SIB 36 02 23

2023-04-19

DISTURBING TIRE NOISE IN THE 30 TO 50 MPH SPEED RANGE

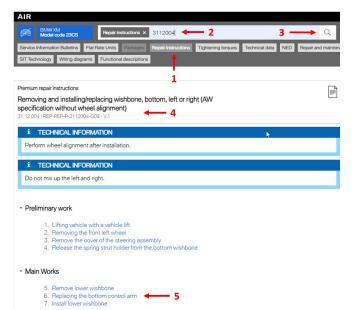
Tire noise from the front axle in the 30 to 50 mph speed range.

The combination of factory-installed wheels/BMW approved tires, control arms and front axle.

G05: Retrofit/install vibration absorbers on the left and right control arms (one-time).

G09: The absorbers should already be installed as standard equipment. If they are not installed, retrofit them (one-time).
